PRE-APPLICATION CONFERENCE NOTES

Franz Ridgefield Short Plat & Site Plan

File No. PLZ-23-0008

PRE-APP SITE PLAN

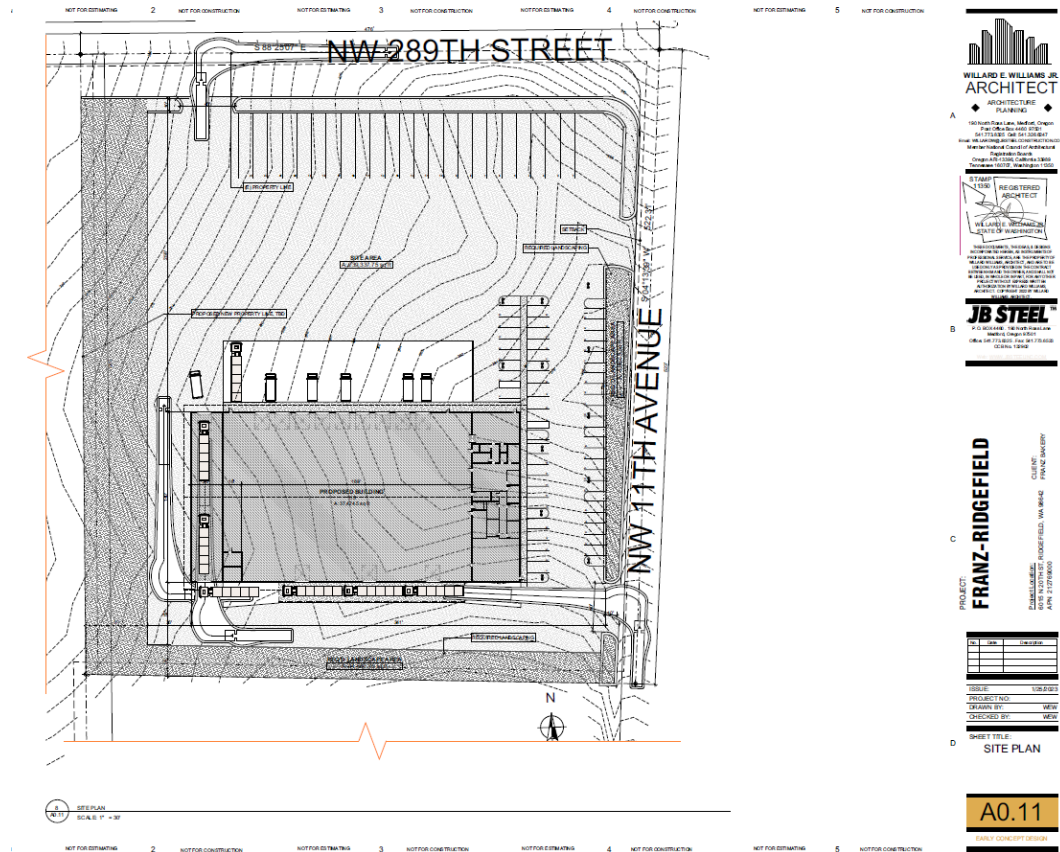
Comment: The project parcel consists of 30.11 acres. Clark County approved the existing manufactured home under review of building file 00081718. The proposed plan appears to comply with the minimum setbacks of the E zone and the applicant is only proposing a building height of 30 feet.

Comment: The applicant will need to reconfigure the building to reinforce the building's location adjacent to the street edge and public space as well as explain how the additional Employment zone site and building design requirements are being met. In addition, the streets shall be relabeled to City of Ridgefield names. Architectural plans showing compliance with the site planning and building design standards in RDC 18.240.060 will need to be submitted with the preliminary application.

Comment: The building will need to be reconfigured to be in compliance with parking standards. In addition, parking will need to be calculated for each use and shown on the proposed site plan. Bicycle parking will be required and need to be shown on the preliminary plan. Pedestrian pathways shall be shown on the plan, including striping details, showing safe walking routes from the parking areas to the building entrances.
